SAFETY RECALL BULLETIN

SUBJECT: Vehicle Safety Recall - RVXX0902
Wiper Motor

RVXX0902, Wiper Motor Recall

Figure 1 — Valeo wiper motor

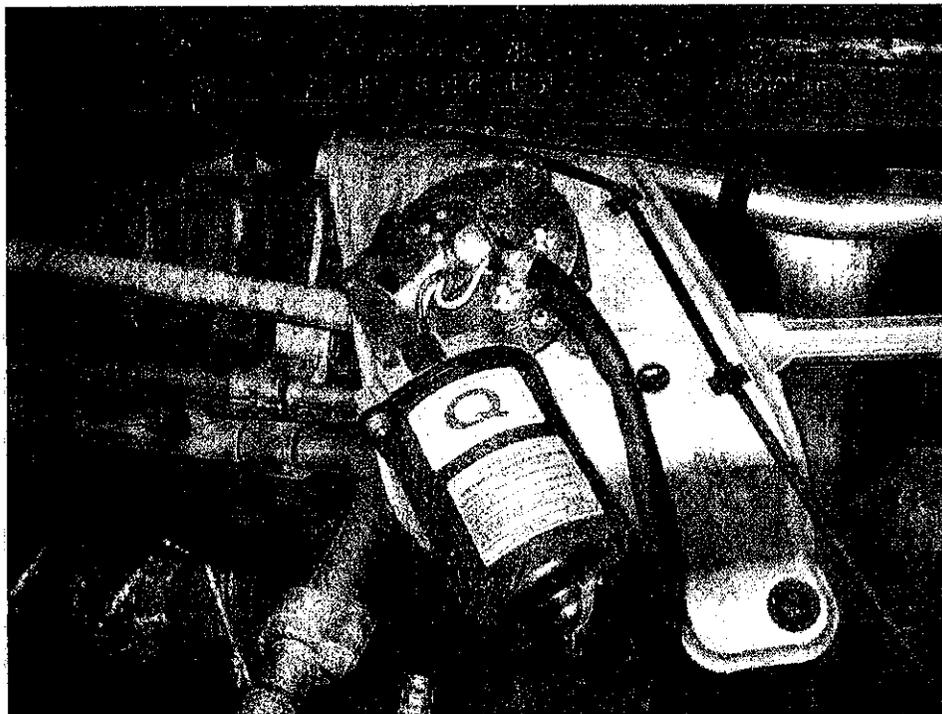
On trucks manufactured from July 1, 2000 through May 11, 2007 and equipped with a Valeo brand windshield wiper motor, the sealer used on the wiper motor may crack and allow water and contaminants to enter the motor and form deposits at cavities located between the electrical traces. The deposits may cause a short between the electrical traces that over time may result in localized overheating which could potentially result in a vehicle fire.

2. Verify that the vehicle has a Valeo wiper motor (figure 1). If the truck already has a Sprague wiper motor (figure 2) installed, file a claim for inspection time using the recall authorization making a appropriate note in the warranty claim.

Part	Part Number	Description
Wiper motor kit (one kit per vehicle)	85122759	Kit includes 1 wiper motor, 3 mounting bolts, 1 linkage retaining nut
Cable ties	980464 (or equivalent)	Cables ties not included in kit

8. Install the new motor using the three new bolts contained in kit 85122759. Start all three bolts before tightening, then torque all the bolts to 11.5 Nm (100 in-lb.).
9. Connect the electrical connector to the windshield wiper motor.
10. Using tie straps (part no. 980464 or equivalent), tie back and secure the motor wiring harness.
